Subject: Data Response, Set 2A
Hidden Hills Solar Electric Generating System (11-AFC-2)

(11-AFC-2)

Hidden Hills Solar Electric Generating System (HHSEGS)

**Data Response, Set 2A
(Response to Data Requests 136 through 143)**

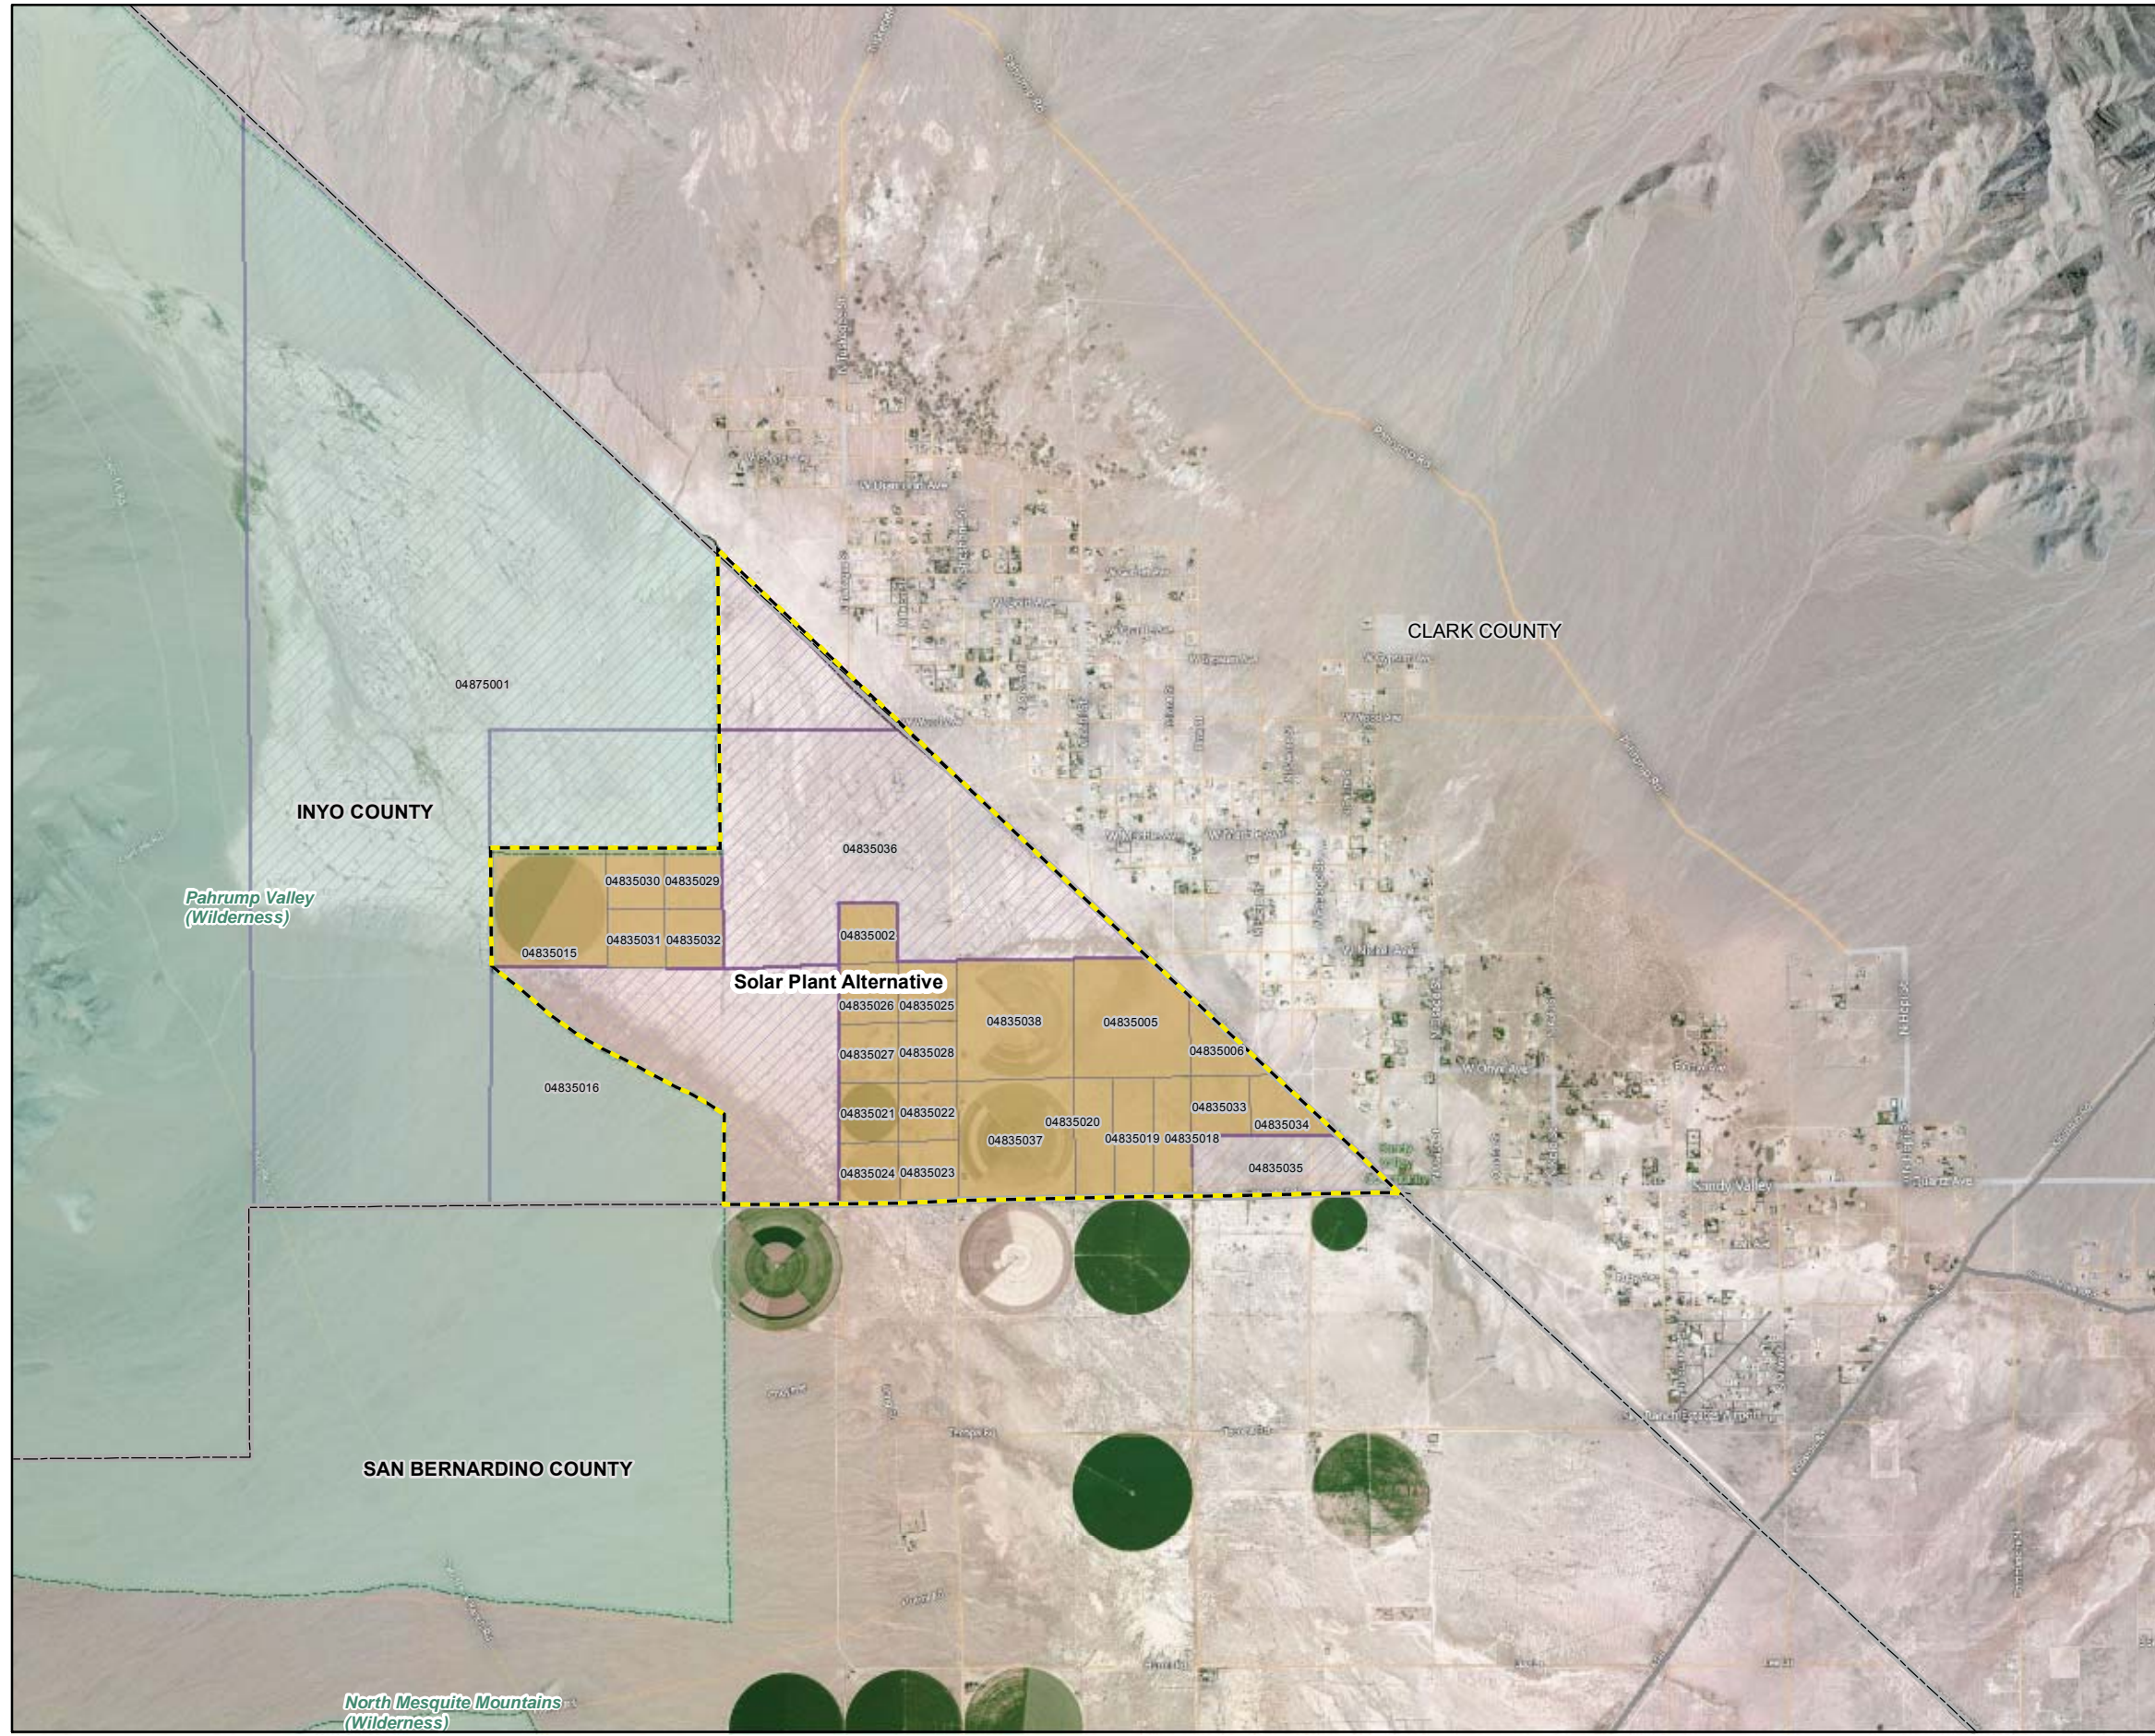
142. Please provide information sufficient to demonstrate the proposed well rehabilitation mitigation strategy is viable.

The collected data show that the wells completed on the project site range from 93 feet to over 1,100 feet deep. Reports indicate that wells on site have been pumped as high as 400 gpm. Two of the wells on the project site, Well 3 and the Orchard Well were test pumped recently and appear to have sufficient production capacities to provide the water required for the project. The capacity of these wells will be confirmed by an extended constant rate pumping test to be conducted in February 2012. Four of the onsite wells are shallow, approximately 93 to 150 feet deep. Two of these wells are dry and the two slightly deeper wells have between 13 and 30 feet of water in the bottom of the wells. The data from the onsite wells indicates that permeable aquifer material is present to at least 1,000 feet below land surface in the area.

The private wells in Charleston View for which the Applicant has construction data range from 175 to 310 feet in depth. The wells were tested at rates between 5 and 30 gpm with specific capacity values reported at 3.5 to 12.5 gpm/ft. Static water levels were reported at between 60 and 156 feet at the time of drilling (1992 to 2006). Water level monitoring data provided by Nye County indicates that water levels west of the state line in the Orchard Well and Quail Well, both on the project site along Tecopa Road (old Spanish Trail Highway), have varied by only 2.5 feet over the last 8 years. This data suggests that the aquifer is relatively stable and has sufficient capacity to support domestic water needs in the area.

The available well data indicates that the aquifer is currently capable of supporting the domestic water needs of the area. The new pumping at the project site is expected to produce additional drawdown of 5 to 8 feet or less, which is not likely to cause a measurable loss in production or significant increase in pumping costs for private wells in the area. The field data show that if remediation of existing offsite wells were required, it would be possible to deepen a pump setting, stimulate a poorly producing well, or drill a deeper replacement well. These methods are all feasible ways to restore the capacity of any well impacted by the project.

FIGURE DR137-1
Potential Solar Plant Alternative and Parcels
for Inyo County
 Solar Plant Alternative Site, Inyo County
 Hidden Hills Solar Electric Generating System

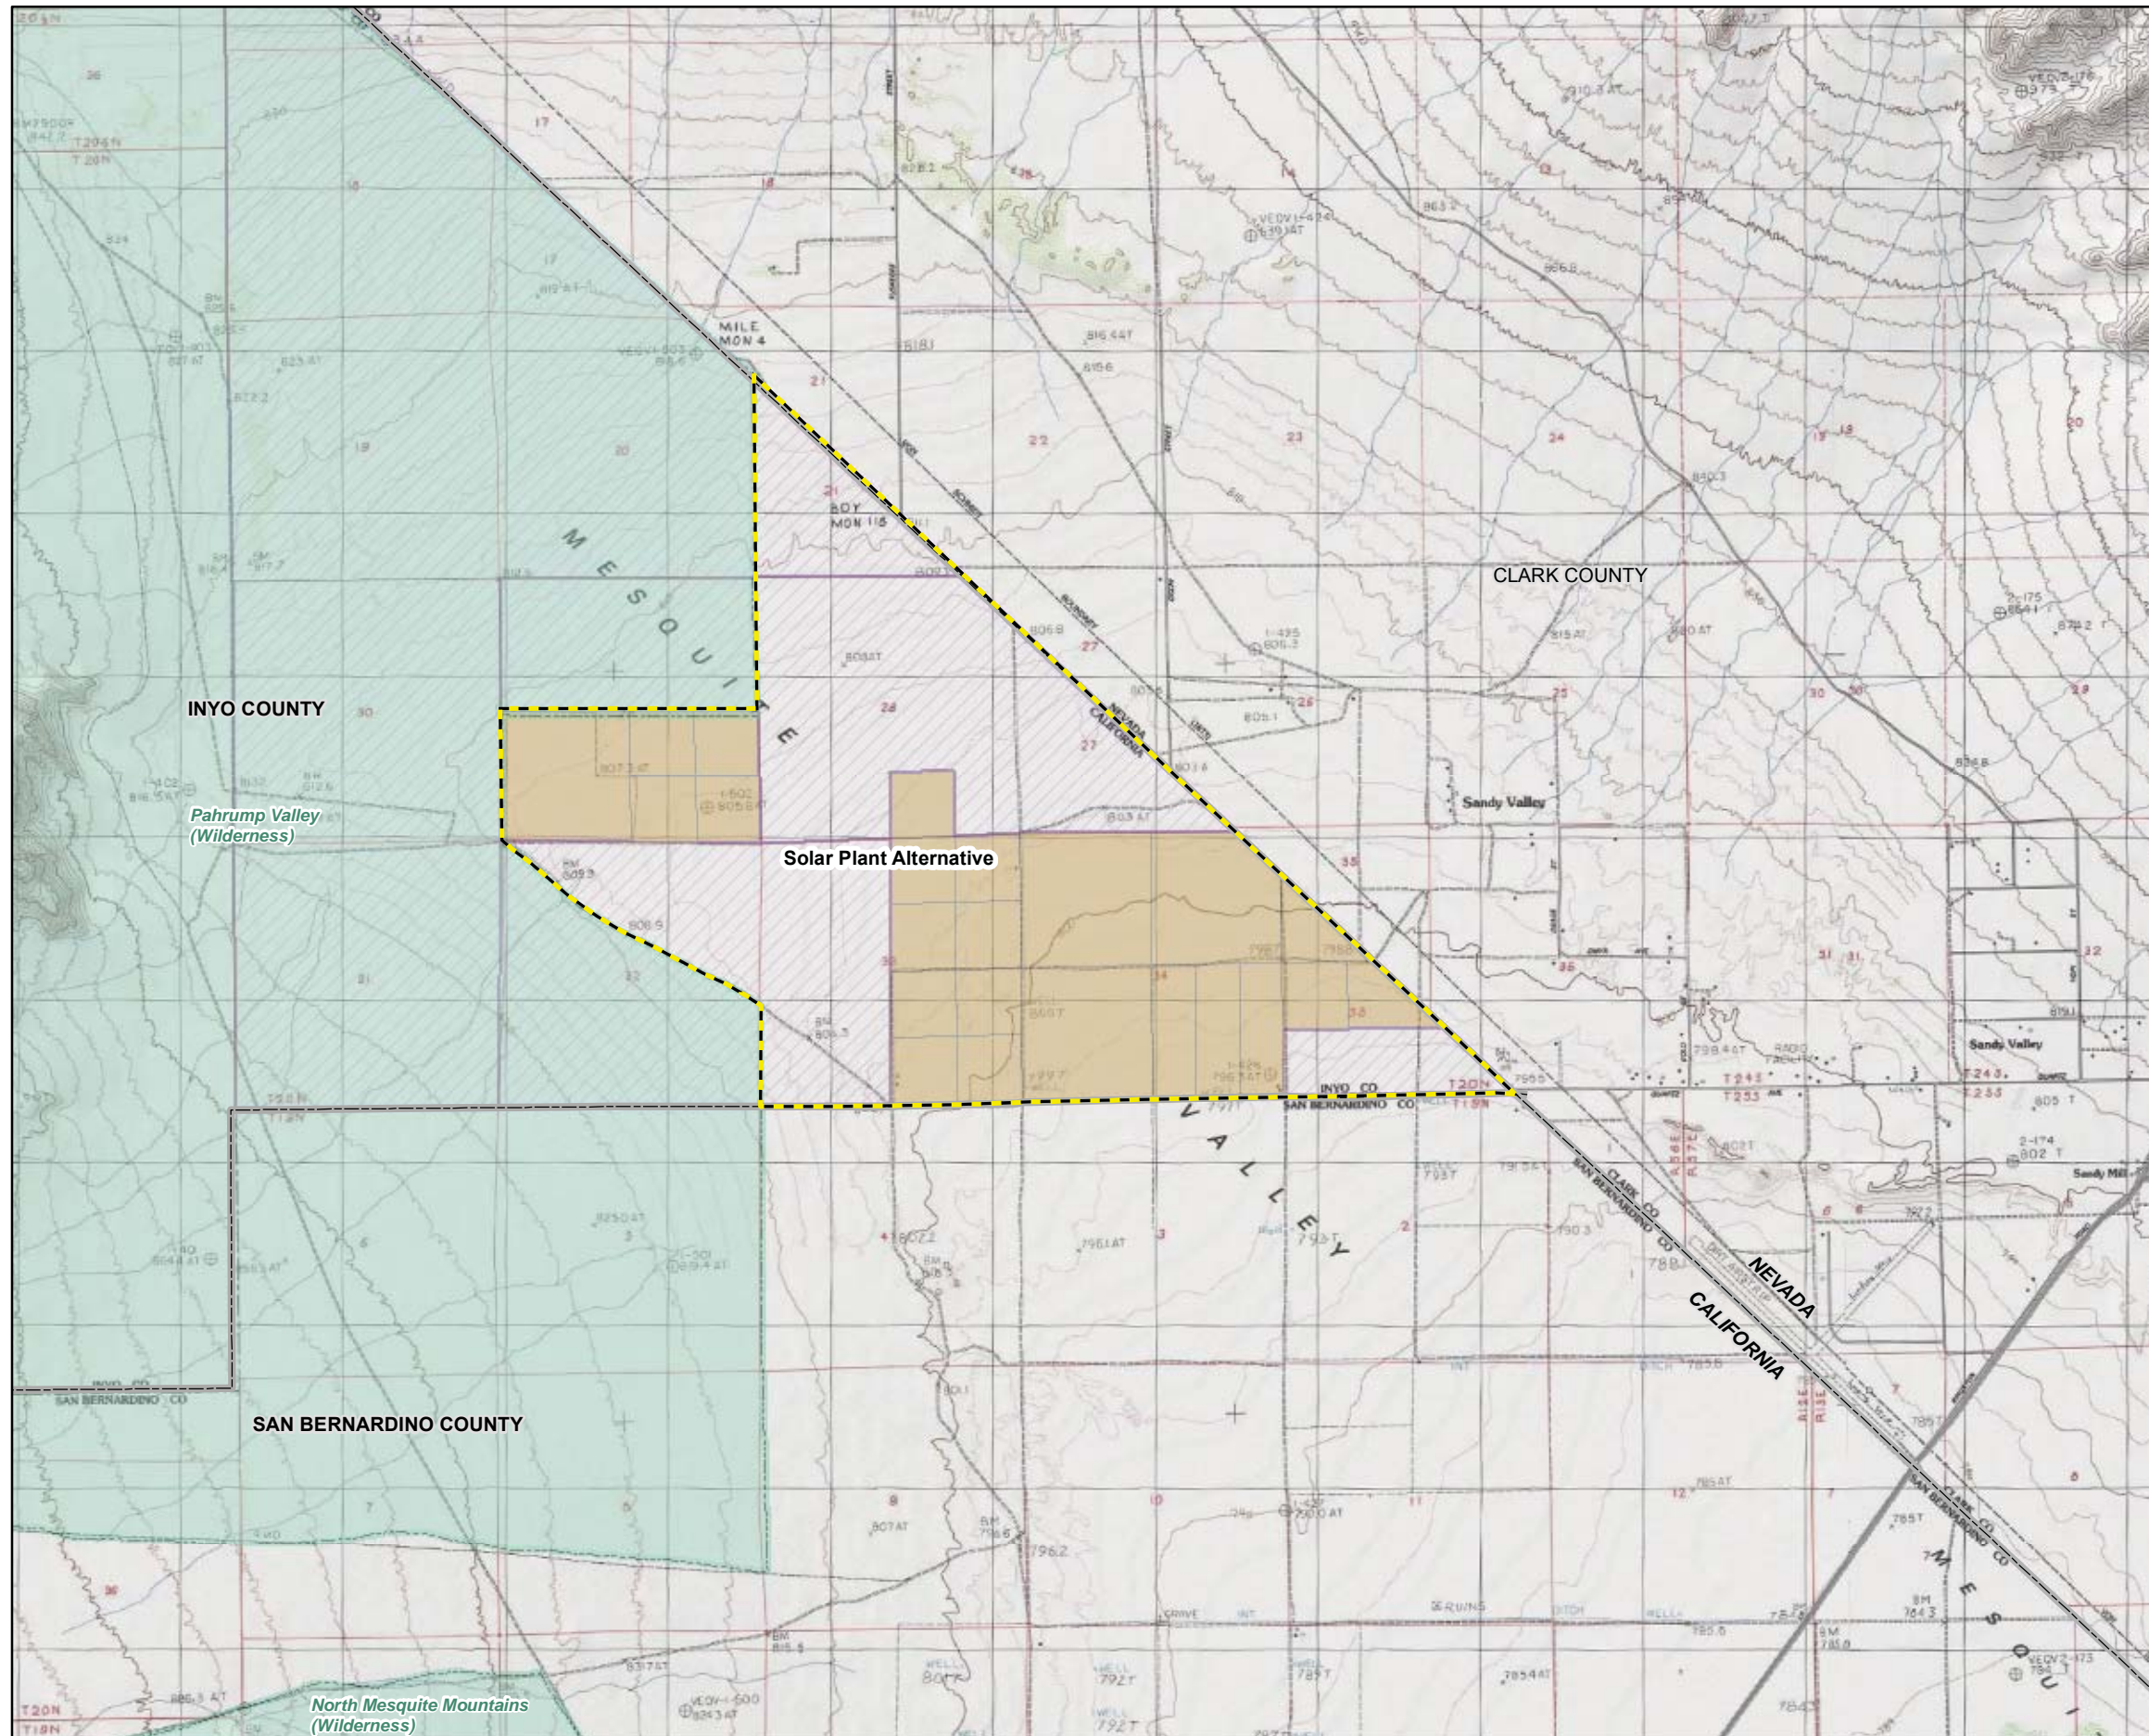
- a. Information on slope and potential available acreage in the area, including potentially available contiguous acreage in the northeast corner of San Bernardino County. Include a map showing a possible project site and footprint. *Provide the shapefile for the figure, including attribute information.* Describe the topography and elevations in the area.

Response: The total potential acreage for a Solar Plant Alternative that is located in Inyo County and not within a wilderness area is 3,119 acres—which is smaller than the HHSEGS project site. A possible project site footprint is shown on Figures DR137-1, titled “Potential Site Alternative and Parcels for Inyo County,” and DR137-2, titled “Potential Site Alternative, Parcels for Inyo County and Elevation Reference.” As shown on Figure DR137-2, this site has relatively flat topography. The requested shape files are included in the enclosed CD, five copies of which are being provided to CEC staff.
